9.0 TECHNICAL SPECIFICATIONS

Calvert Cliffs 1 Cycle 8
Technical Specification Changes
Excluding HPSI Flow Changes

Calvert Cliffs 1 Cycle 8
Technical Specification Changes
Concerning HPSI Flow

FIGURE 4.2.1
Augmentation Factor vs
Distance from Bottom of Core

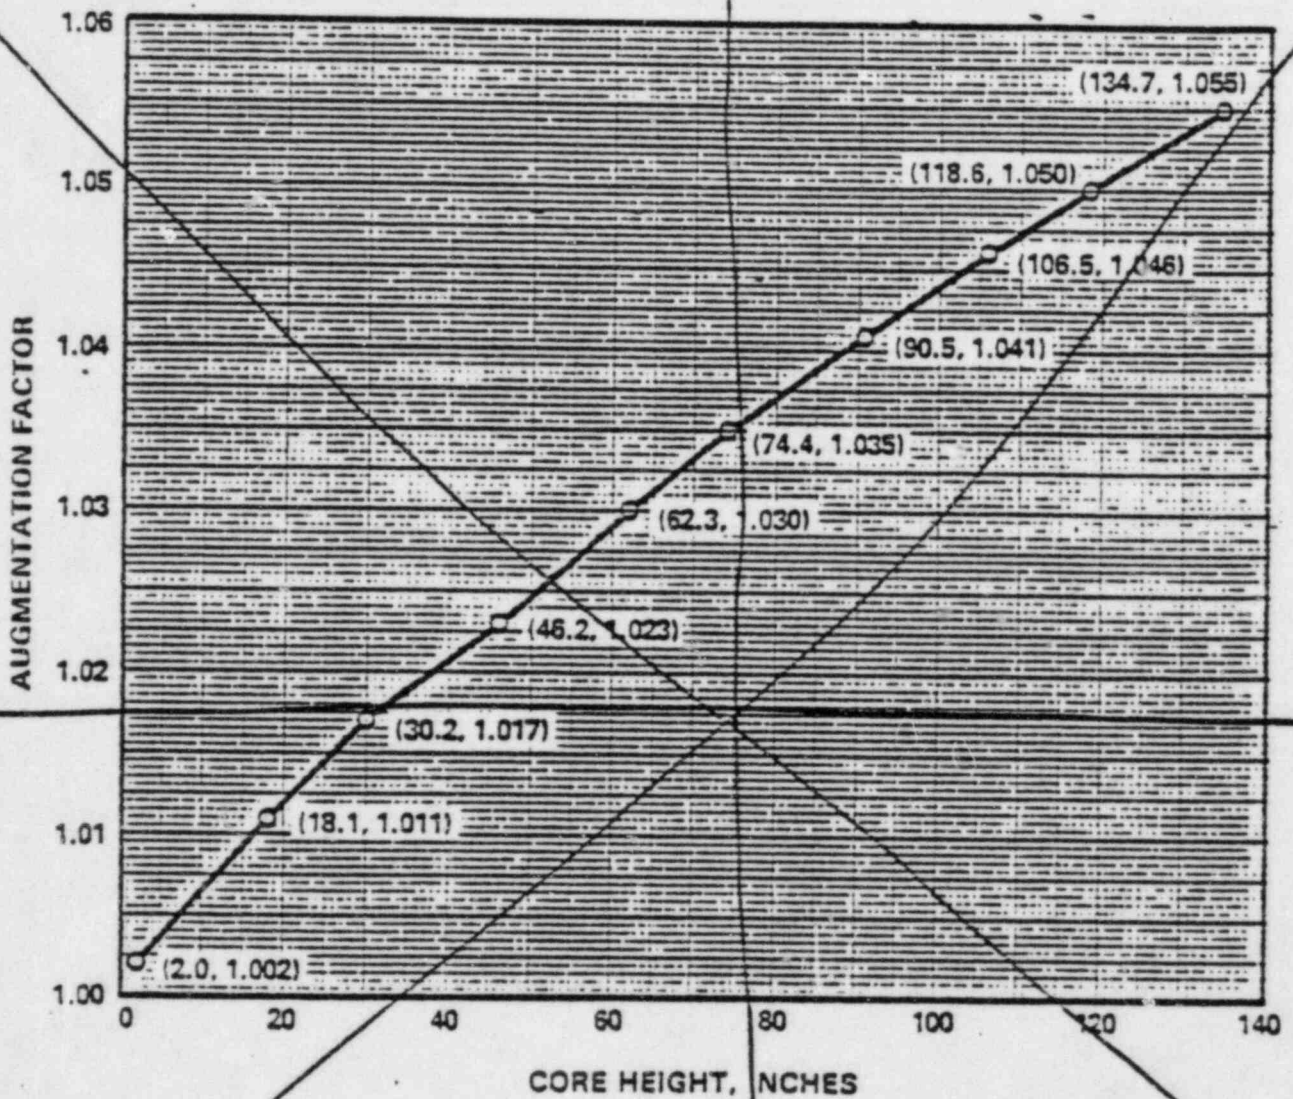
<u>Tech. Spec. No. and Page</u>	<u>Action</u>	<u>Explanation</u>	<u>Support</u>
4.2.1.4 page 3/4 2-2	Remove flux peaking augmentation factors	Augmentation factors are being removed in recognition of the demonstrated lack of gap formation in pre-pressurized non-densifying fuel and to increase operating margin.	<ol style="list-style-type: none"> 1) Detailed discussion and data was presented in Reference 1 to support this change. 2) The thermal design analysis of the fuel pins presented in Section 4.3 supports the change. 3) The ECCS performance analysis for the large break spectrum presented in Section 8.1 supports this change.
	Reduce the measurement-calculational uncertainty from 7.0% to 6.2%	This uncertainty is being reduced to conform to the approved value and to increase operating margin.	<ol style="list-style-type: none"> 1) The new value is supported in Reference 2. 2) The thermal design analysis of the fuel pins presented in Section 4.3 supports this change.

~~1. Flux peaking augmentation factors as shown in Figure 4.2-1;~~

DELETE

B 3/4.2.1 page B 3/4 2-1	Remove flux peaking augmenta- tion factors, change measurement- calculational uncertainty from 7.0% to 6.2% and change axial fuel densification and thermal expansion factor from 1.0% to 0.2%	See change for Tech. Spec. 4.2.1.4.	See change for Tech. Spec. 4.2.1.4.

Figure 3.2-4
DNB Axial Flux Offset Control Limits

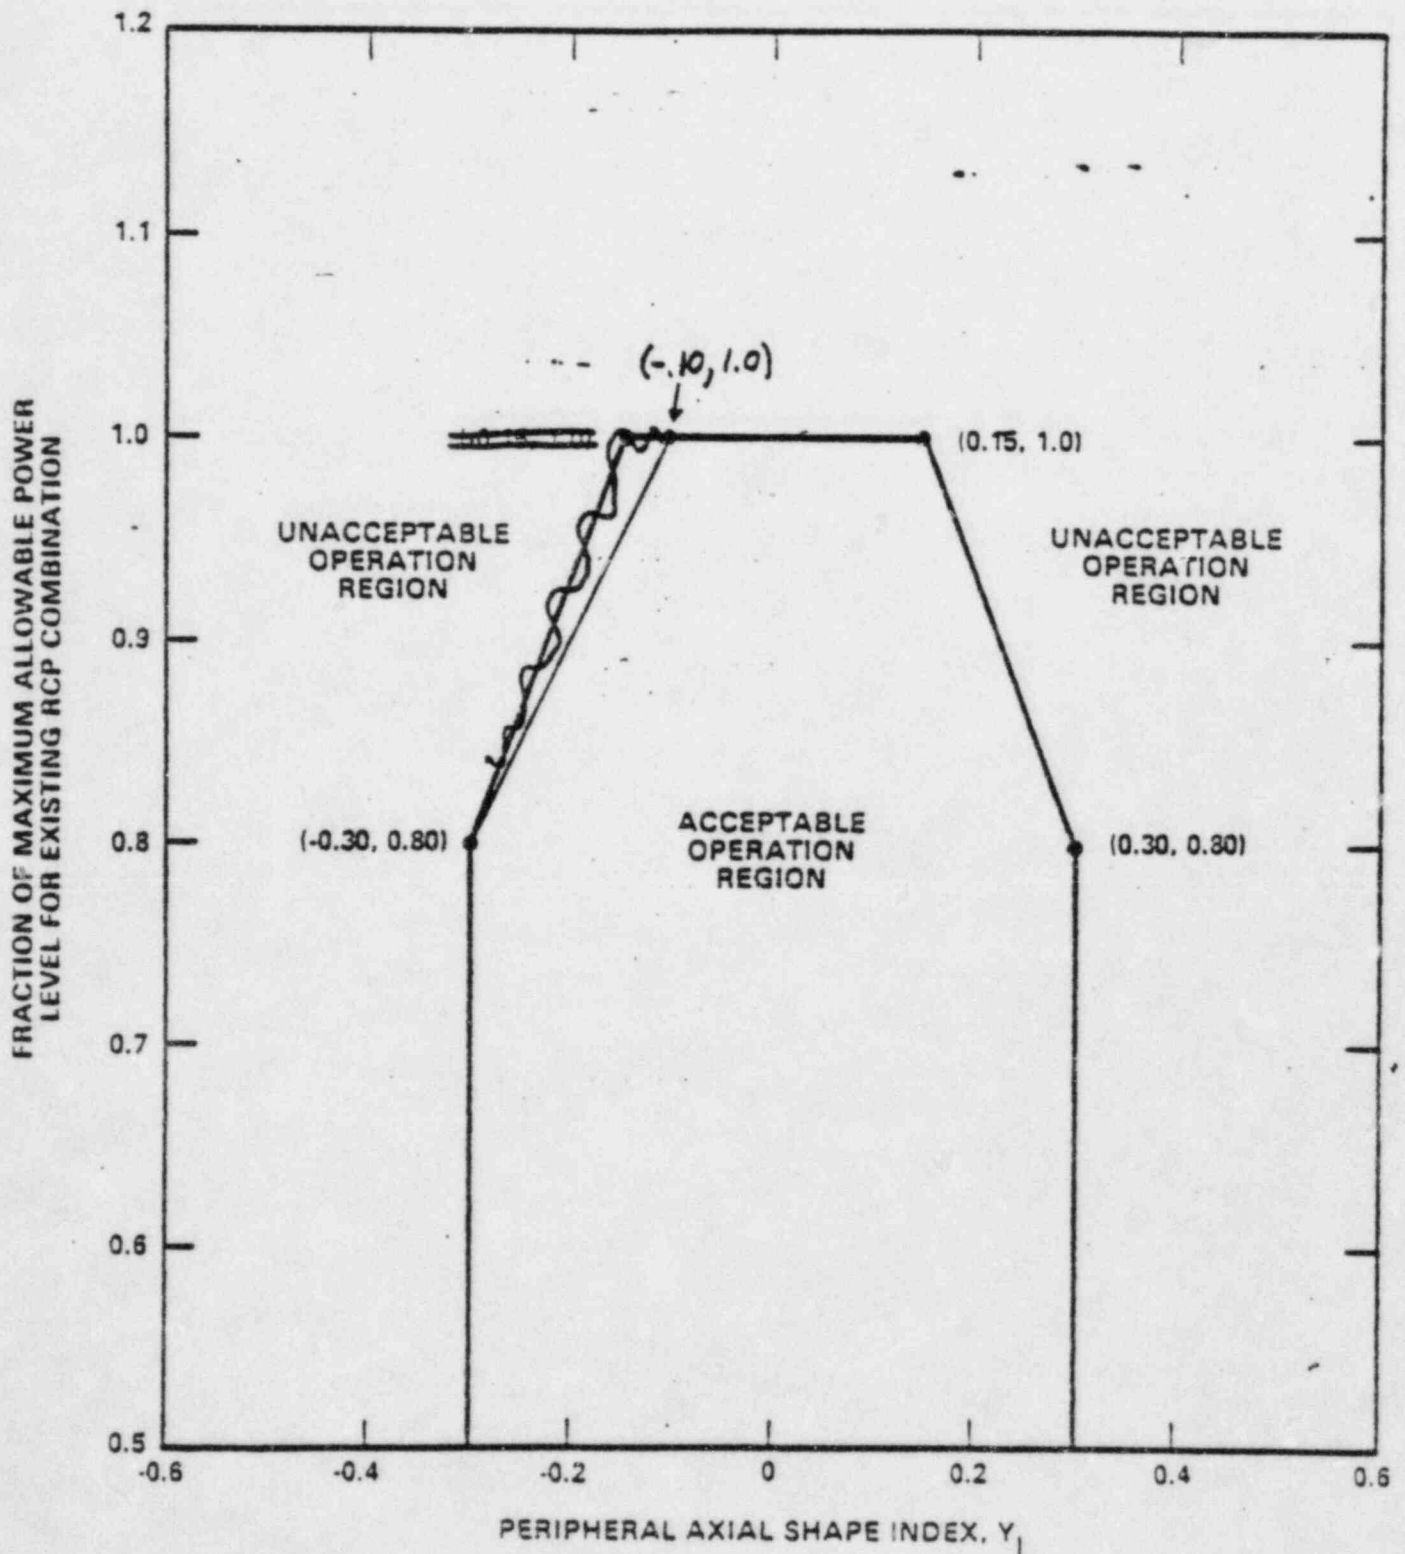
← INSERT NEW PARAGRAPH (A) HERE (A) IS ON NEXT PAGE

In addition to the DNB criteria, there are two other criteria which set the specification in Figure 3.2-4. The second criteria is to ensure that the existing core power distribution at full power is less severe than the power distribution factored into the small-break LOCA analysis. This results in a limitation on the allowed negative AXIAL SHAPE INDEX value at full power. The third criteria is to maintain limitations on peak linear heat rate at low power levels resulting from Anticipated Operational Occurrences (AOOs). Figure 3.2-4 is used to assure the LHR criteria for this condition because the linear heat rate LCO, for both ex-core and in-core monitoring, is set to maintain only the LOCA kw/ft requirements which are limiting at high power levels. At reduced power levels, the kw/ft requirements of certain AOOs (e.g., CEA withdrawal), tend to become more limiting than that for LOCA.
